**Re: Springvale Mine Extension Project – Response to OEH Submission**

**Response to OEH Submission on Springvale Mine Extension Project dated 12 June 2015**

Figure 1 – Sensitivity of Void Widths on Subsidence at DoC 360 m and 400 m

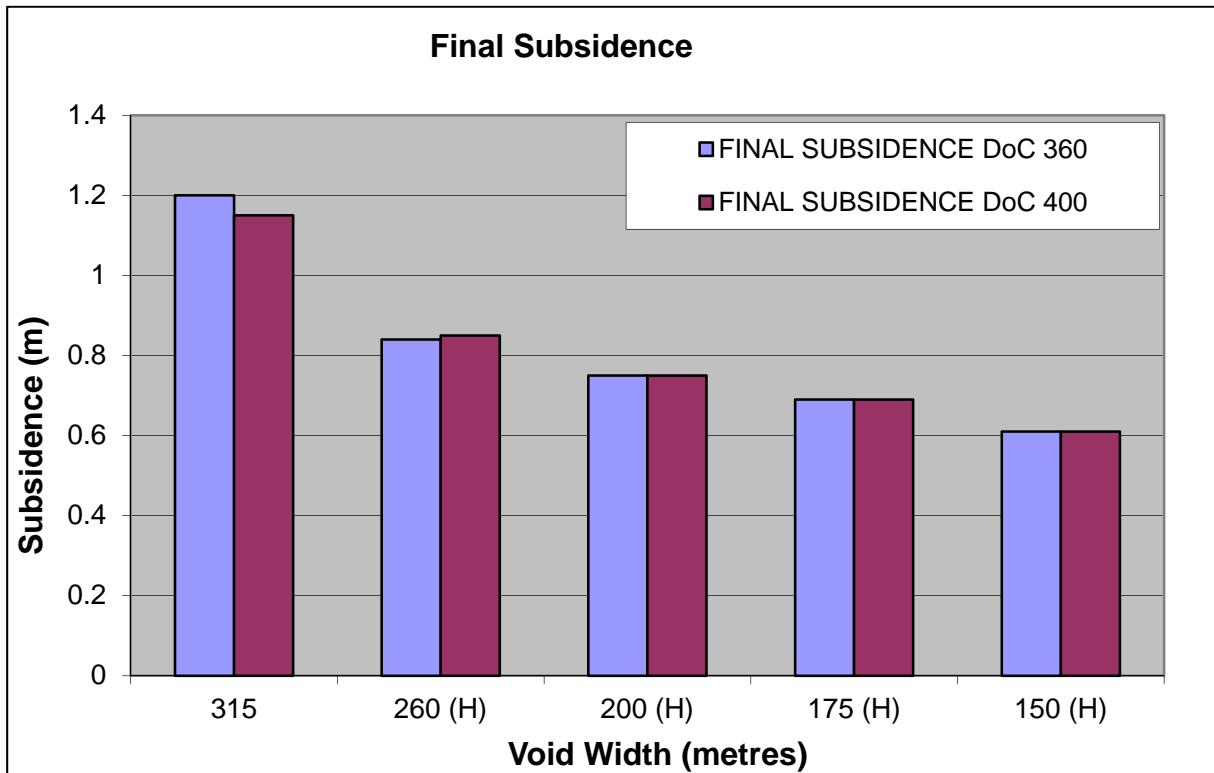
*OEH has consistently stated that it does not support the direct undermining of Newnes Plateau Shrub Swamps EEC using the longwall mining technique unless there has been a modification to the mining techniques that will ensure that impacts will be prevented.*

- Only marginal subsidence reductions for longwall void widths occurs between 150 m and 260 m while the greatest reductions can be made from 315 m to 260 m void widths (refer **Figure 1, Attachment 1**).

The data presented in **Attachment 1** show that narrowing the void width widths to significantly less than 261 m does not significantly reduce subsidence to afford additional environmental advantages, however, comes at a cost to the business viability at Springvale Mine.
